Soultex Fashion Ltd

5 May 2024

2. Observation

Observation-01: Lack of lateral stability system (Main Building).

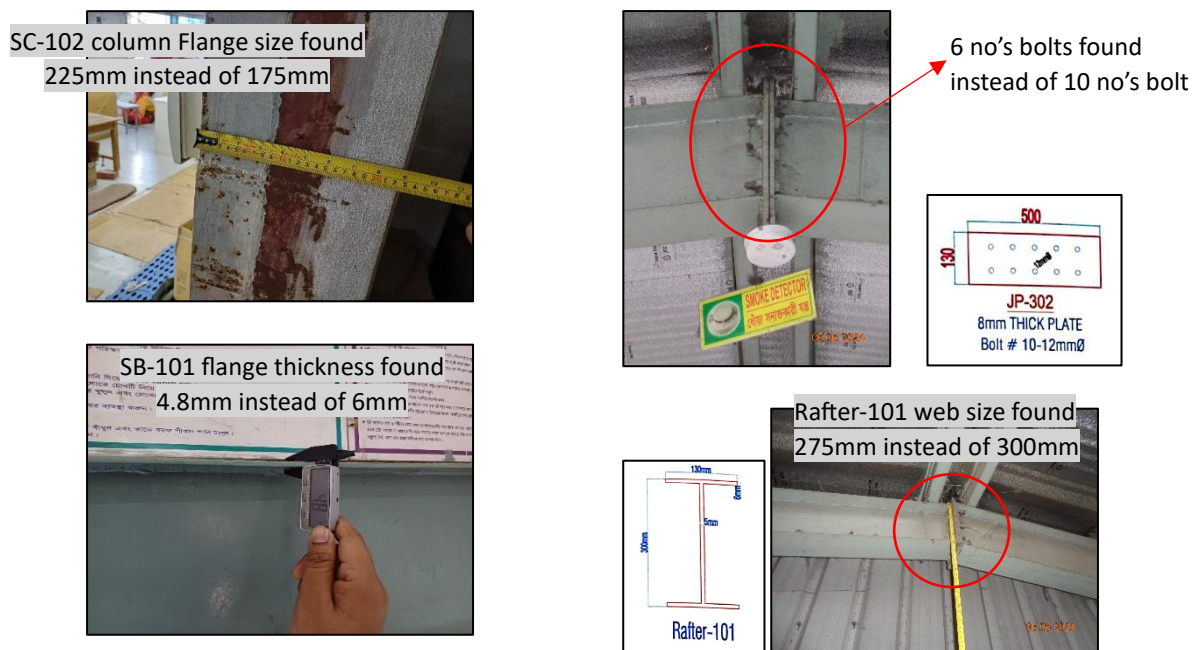
Description: The compression member was absent in the bracing system which may cause inactive lateral stability of the roof. Also, for the ground floor, pin connection is provided along east-west direction, but no vertical bracing or resisting system is provided along that direction.

During inspection, geotechnical investigation report was not available. Also load plan was not found for the Main building.

The building engineer is required to check the lateral stability system of the structure, perform geotechnical investigation & check foundation adequacy for the structure, Produce & actively manage a loading plan for all floor plates within the factory based on floor, column & foundation capacity and suggest necessary remedial action accordingly.

Observation-03: Mismatch found in structural drawings (Main Building).

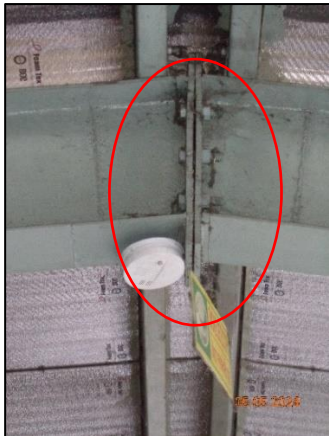
Description: Mismatch was observed in beam, rafter and column of Main building's drawings. Also, the drawings for the sub-structure were not available.

The building Engineer is required to survey the whole structure and prepare the as built drawings as per site condition.

Observation-05: Connection gap at different locations (Main Building).

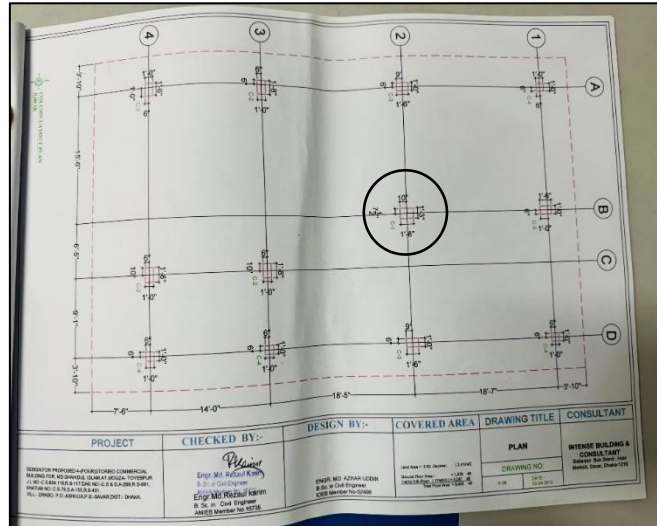
Description: During inspection, connection gap was observed at different location of Main building. The factory is required to fill the connection gap as per adequate techniques.

Observation-07: Stress in column exceeds normal design limit (RC Building).

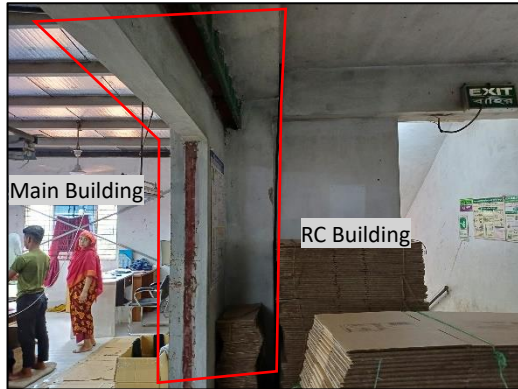
Description: The cursory calculation indicates that stress in the marked column exceeds the normal design limit considering provided floor live load of 6 kPa for typical floor, roof live load of 1 kPa and minimum concrete strength of 14.1 MPa.

During inspection, the geotechnical report was not available to check the foundation capacity of the structure. Also, no material test report was available.

The building engineer is required to review the design, loads, and column stresses for the marked columns based on in-situ material strength, perform geotechnical investigation to check foundation capacity. The building engineer is also required to produce and actively manage a loading plan for all floor plates based on floor, column and foundation capacity.
